CCK-2564.0-16-25 HEB BP-05 Interiors

ADDENDUM #2

UK Construct Health Education Building
ADDENDUM No. 2
UK-2564.0-16-25
01/13/2025

ITEM NO. 2.03

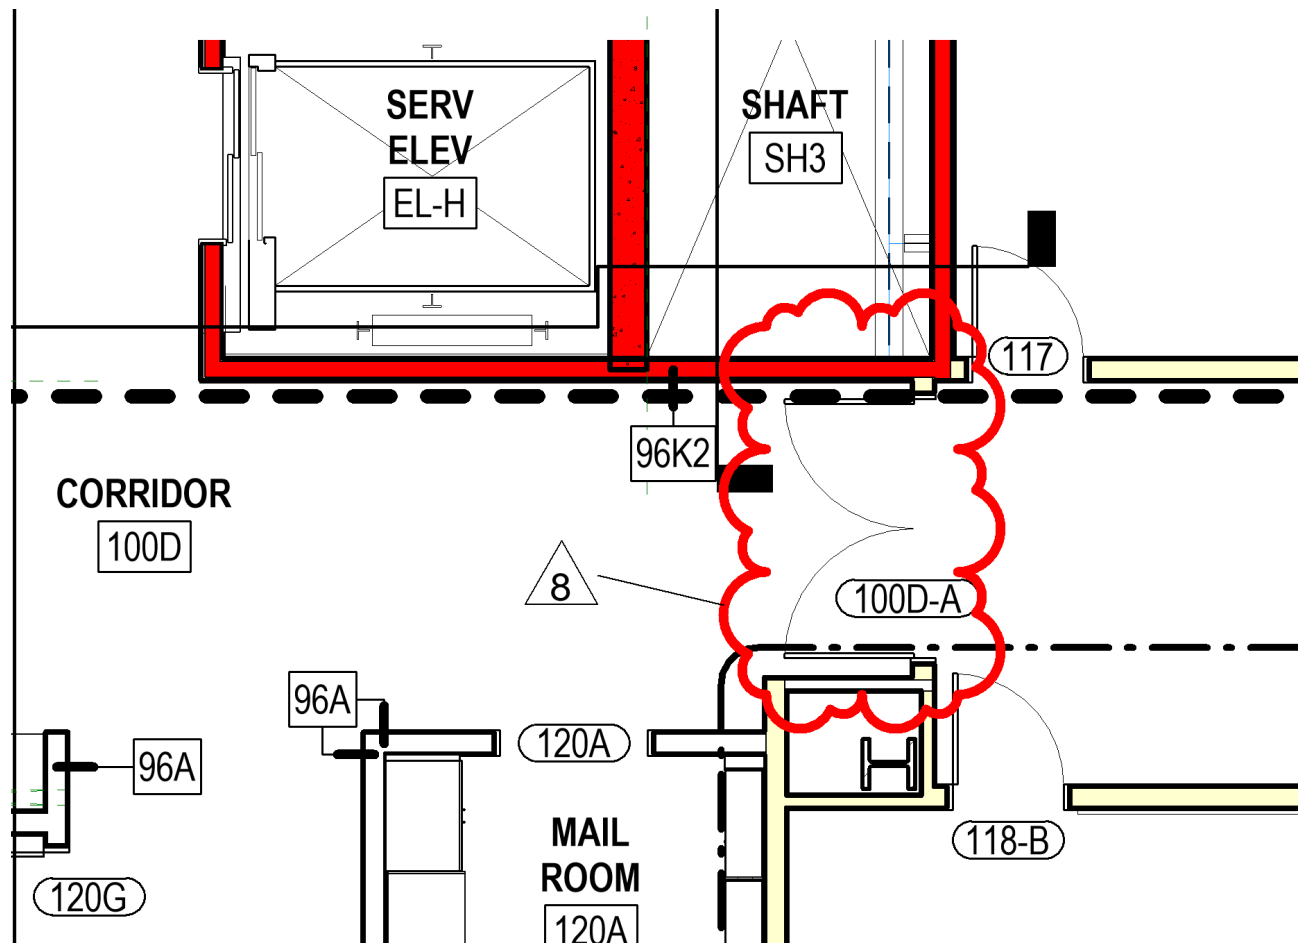
During BIM Coordination. Mechanical/Plumbing piping coming out of Shaft 3 caused a shift in Door 100D-A.

ITEM NO. 2.14

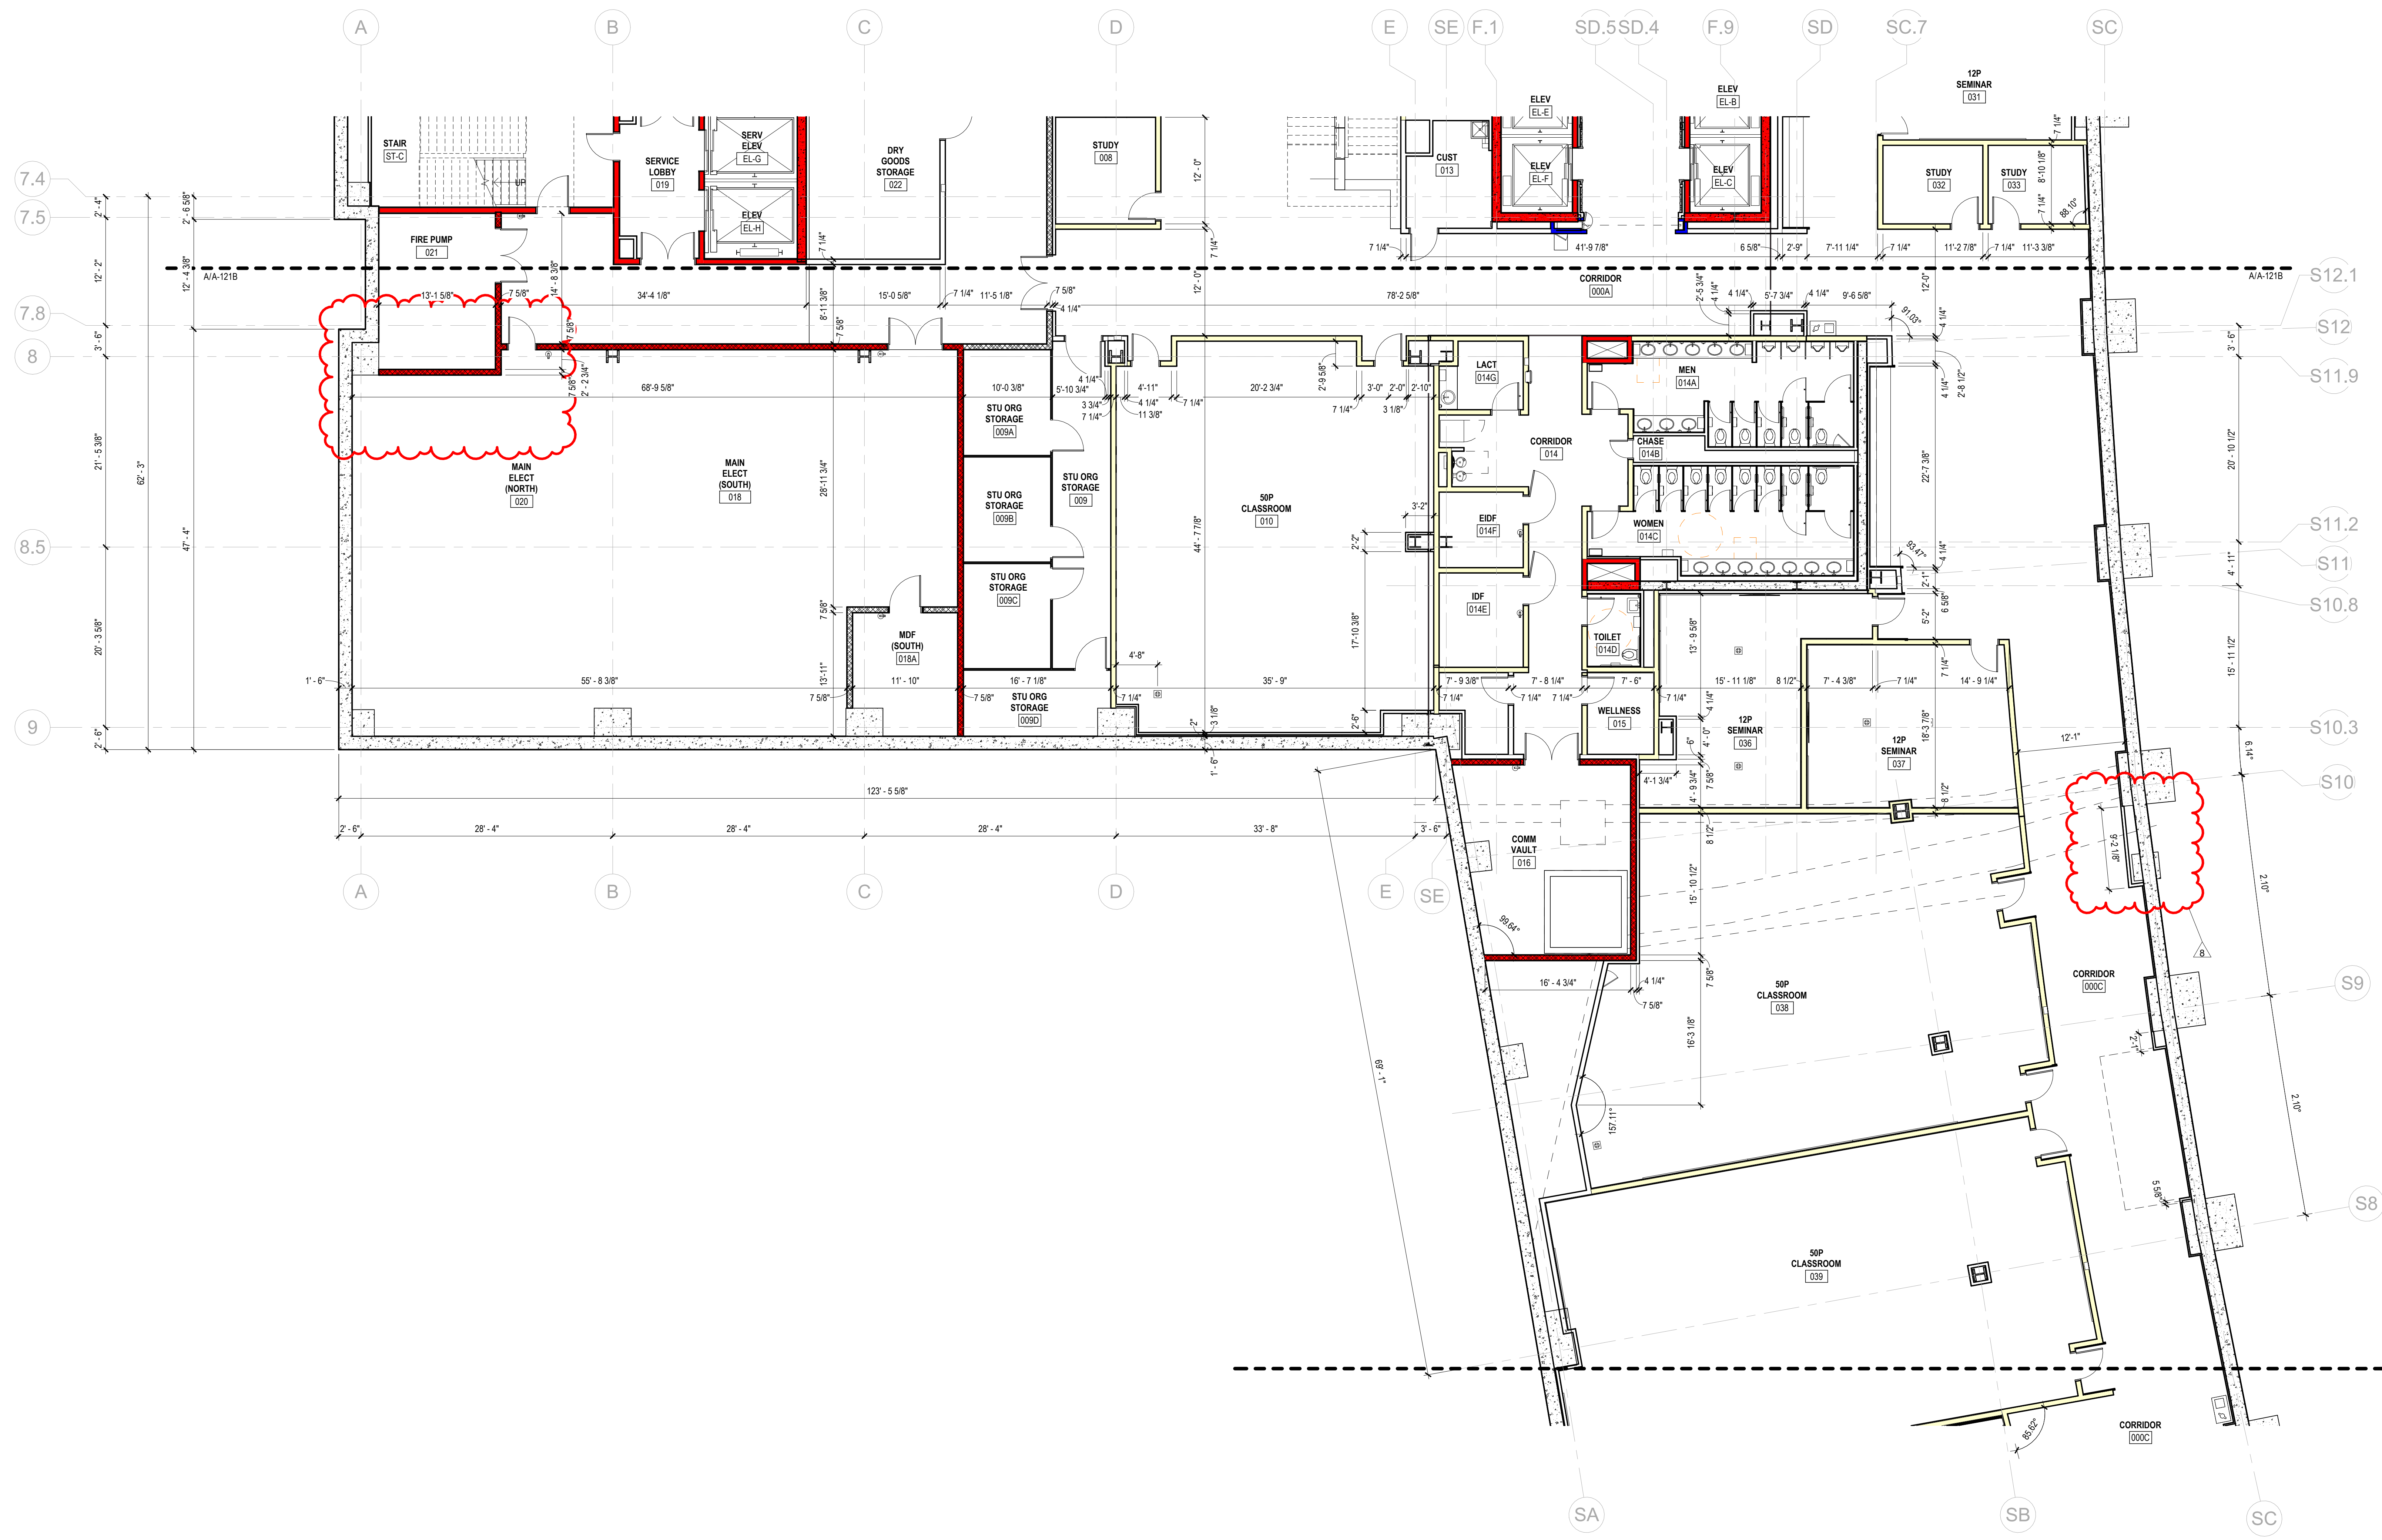
Refer to drawing IT-209B – IT REFLECTED CEILING PLAN – NINTH FLOOR FLOOR – AREA B

- A. Add tagged note IT62 to indicate corridor cable tray is to be 18" wide.

E-301B
COPYRIGHT 2024 - JRA, INC.

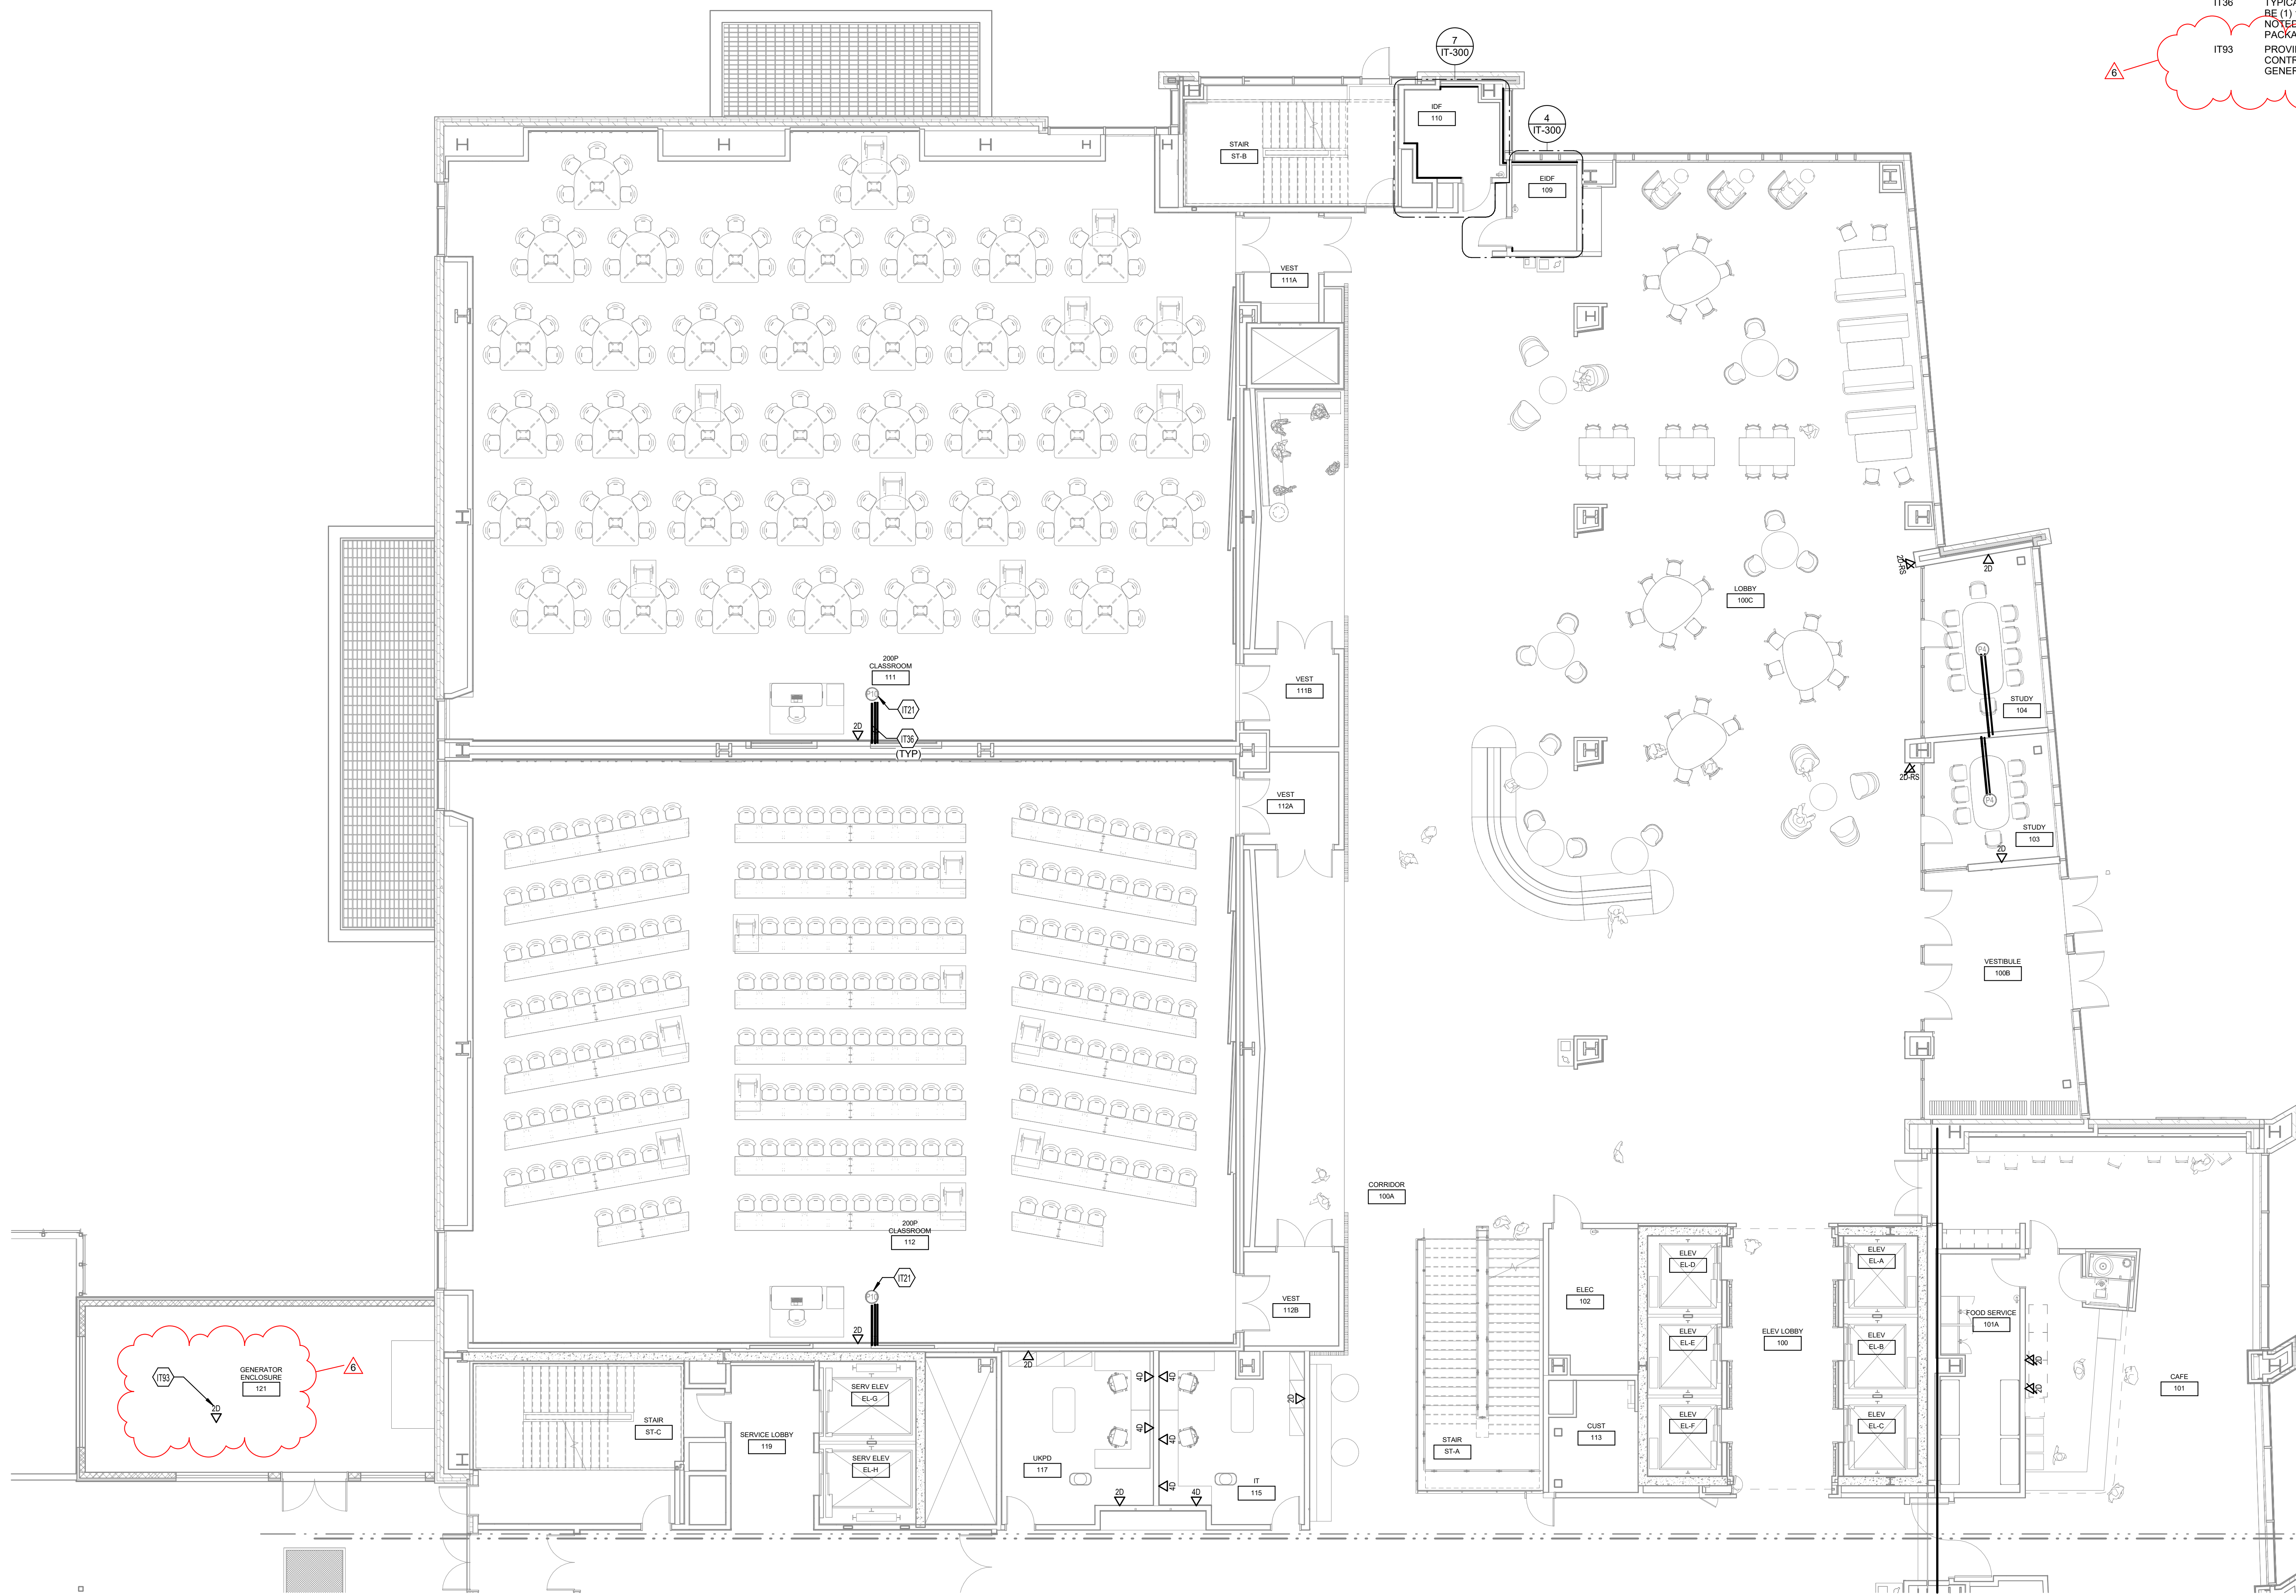
Refer to drawing E-301B – SYSTEMS PLAN – FIREST FLOOR – AREA B

BB. BASE BID: PROVIDE THREE (3) AUDIOVISUAL CEILING MOUNTED NOTIFICATION DEVICES SPACED UNIFORMLY THROUGHOUT THE BORDERED AREA.
ALTERNATE BID: PROVIDE ALL WORK SHOWN ON PLAN.
